BURLINGTON DEVELOPMENT REVIEW BOARD

Tuesday, October 6, 2020, 5:00 PM

PUBLIC HEARING NOTICE

TO: Development Review Board
FROM: Ryan Morrison, Associate Planner
DATE: October 6, 2020
RE: 21-0266CA; 1 King Street

ELEVATION SHOWING SHED DORMER: ELEVATION-2

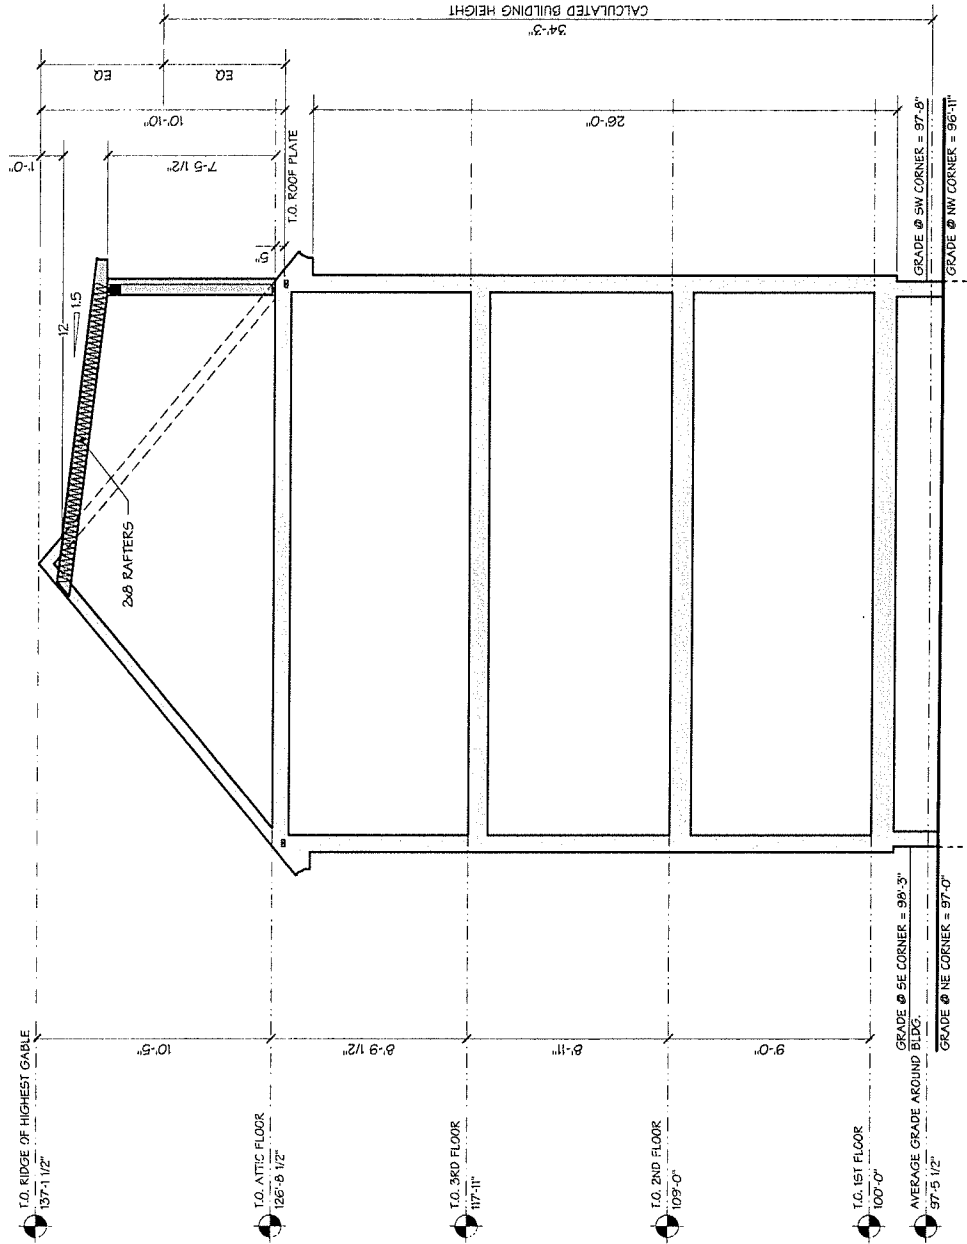
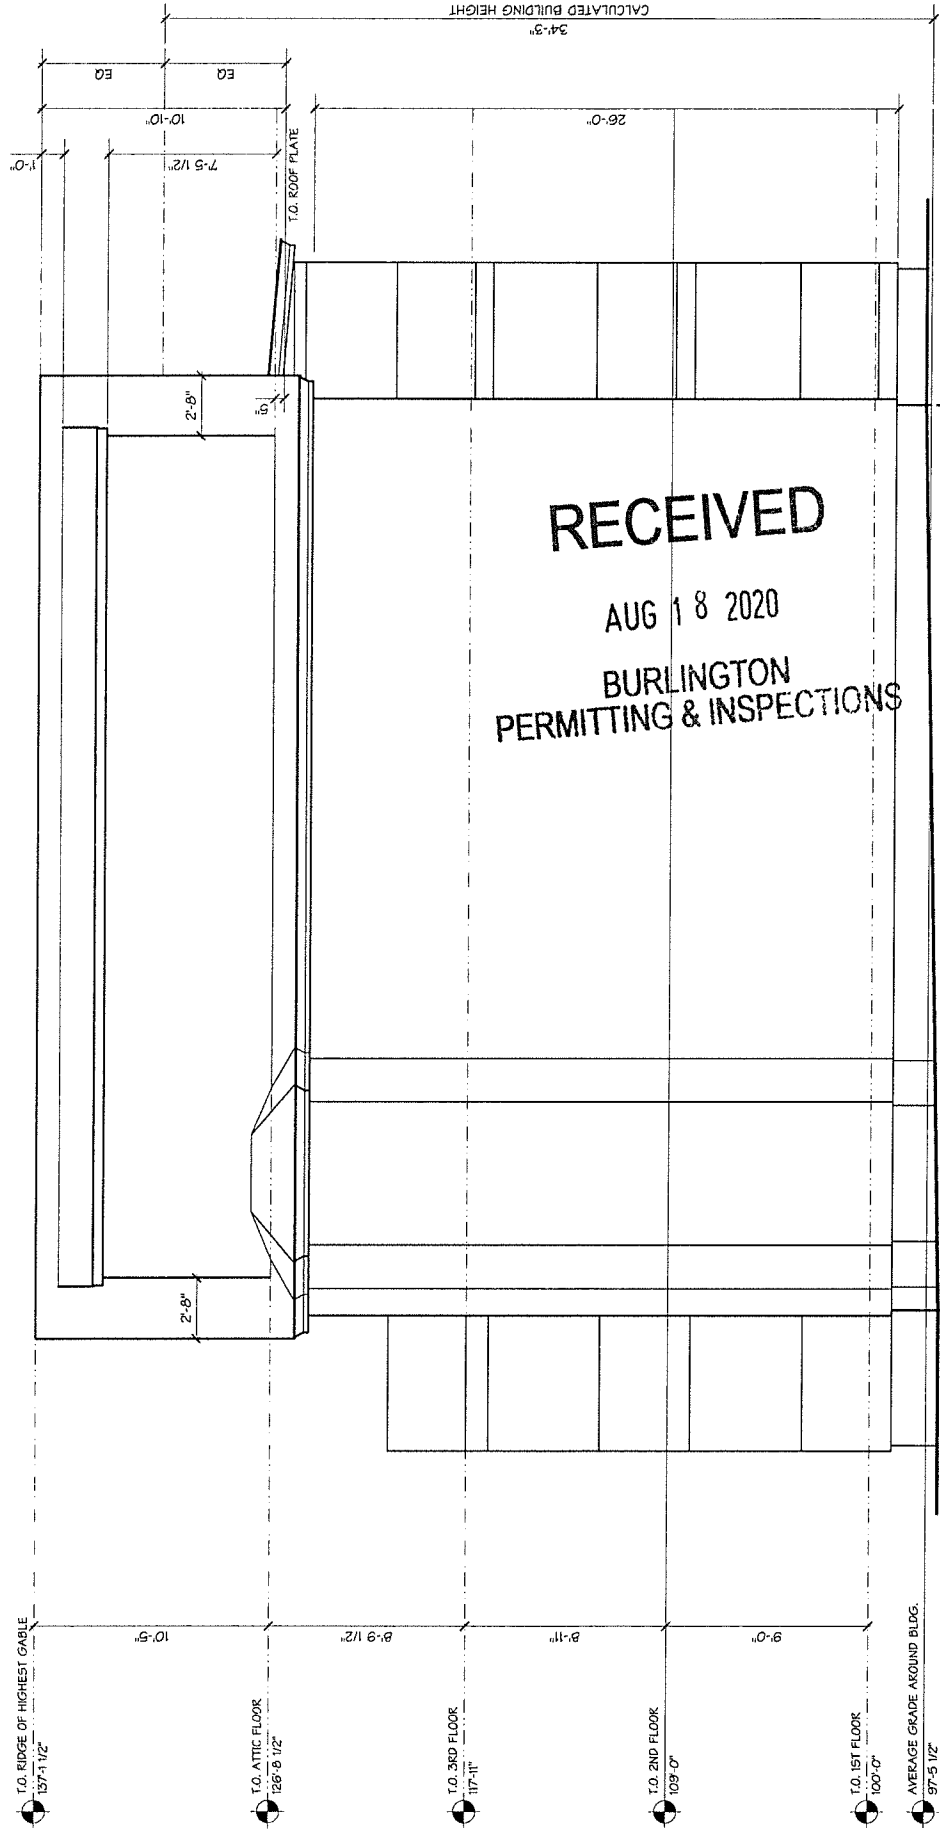
Sec. 5.2.6, *Building Height Measurements*, of the Comprehensive Development Ordinance articulates specific provisions for height measurement of several different roof forms. What you are proposing at 15-17 Monroe Street is not specifically addressed. In such cases, the CDO refers height measurement of "other roof forms" to the determination of the administrative officer in a manner that most closely reflects the intent of the height measurement standards. Item (a), 2, B of Sec. 5.2.6 offers some guidance and states that a double-pitched roof shall be measured to the roofplate of the highest pitch. Double-pitch is not defined in the CDO; however, reference is made to a gambrel or double-pitch mansard roof forms. Double-pitch could also simply mean two different pitches. Such is the case for the full shed dormer at 15-17 Monroe Street. Using the standard in Sec. 5.2.6, (a), 2, B, height of the structure with a full shed dormer would be measured to the roofplate of the full shed dormer.

In sum, the introduction of a full shed dormer at 15-17 Monroe Street would significantly increase upper story building volume and would consequently increase the overall height of the building.
